Department of Environmental Conservation

Record of Decision
Irvington Waterfront Park
Environmental Restoration Project
Village of Irvington, Westchester County
Site Number B-00004-3

DECLARATION STATEMENT ENVIRONMENTAL RESTORATION RECORD OF DECISION

**Cross Section
of Soil Cover
Figure 3**

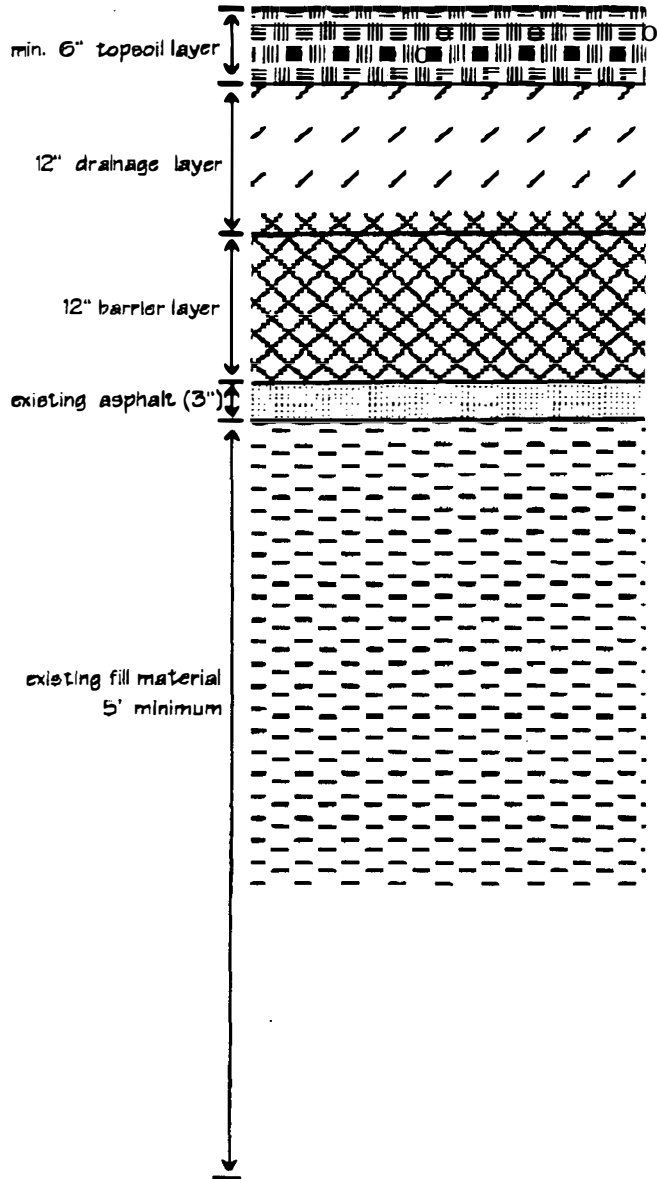
In response to our concern about truck traffic, the Village is continuing to explore the utilization of barge or rail for the transport of soil. However, it has come to our attention that a material exists known as a Geosynthetic Clay Liner (GCL). We understand that this material has many advantages over soil including added protection and reduced cost. We recommend that this material be considered as a substitute for the barrier layer (12") in the Record of Decision.

The Village of Irvington has recommended that the NYSDEC consider the use of a Geosynthetic Clay Liner (GCL) material as a substitute for the 12-inch soil barrier specified in the Proposed Remedial Action Plan (PRAP). The Village cites reduced truck traffic and lower cost as significant advantages of this material. The analysis which follows is to determine whether the environmental and public health protection factors provided by the 12-inch soil layer would be equivalently met by a GCL.

Substitution of a GCL would reduce the total cover thickness from 30" to 18". However, this thickness would still be sufficient to eliminate the direct routes of exposure. The geotextile layers would serve as a “warning layer” to potential unanticipated digging through the cover that would not be provided by the soil barrier. However the asphalt layer would provide the most effective physical barrier to direct contact with the fill under both options.

With regard to your comment on the Geosynthetic Clay Layer (GCL), the DEC considers this material to be a variant within the general category of a soil barrier layer, and not a distinct alternative requiring evaluation. Nevertheless, this material must fulfill the specific health and environmental protection functions that have been established for the project. The enclosed "Equivalent Design Analysis" demonstrates the ability of a GCL to perform the equivalent function as a 12-inch soil barrier, with additional environmental benefits. In that analysis, salient aspects of the 7 detailed evaluation criteria are also discussed.

Because a GCL would provide equal or superior performance in the protection of public health and the environment, it will be considered as an engineered equivalent in the remedial design. The Record of Decision will allow the use of an engineered equivalent of the soil barrier for all or part of the cover system.

**Cross Section
of Geomembrane
Figure 4**

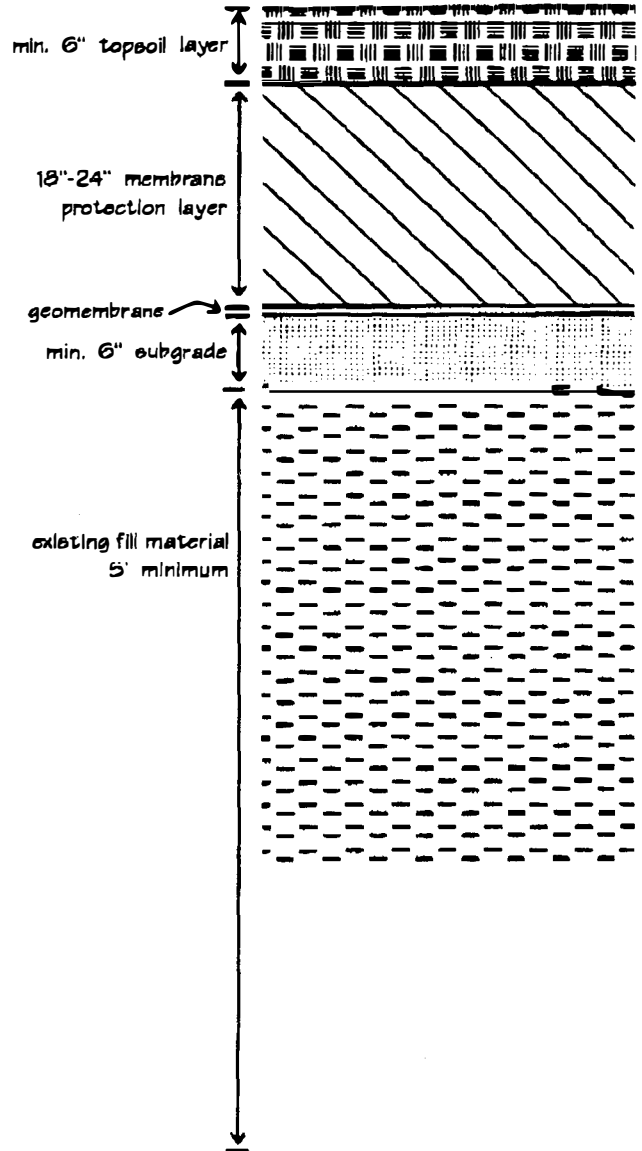
Question/Comment: The commenter agreed that the membrane cap is not necessary. Will it be possible to plant trees on the soil cover?

Response: It will be possible to plant some trees on the site, provided that the location of trees is identified early in the soil cover design. Trees can be planted in "wells" created in the fill and lined with low permeability soil. Trees and shrubs could also be planted on berms of thicker fill placed above the soil barrier layer. The location of wells and berms must be known when the barrier layer is designed, so that proper drainage can be provided.
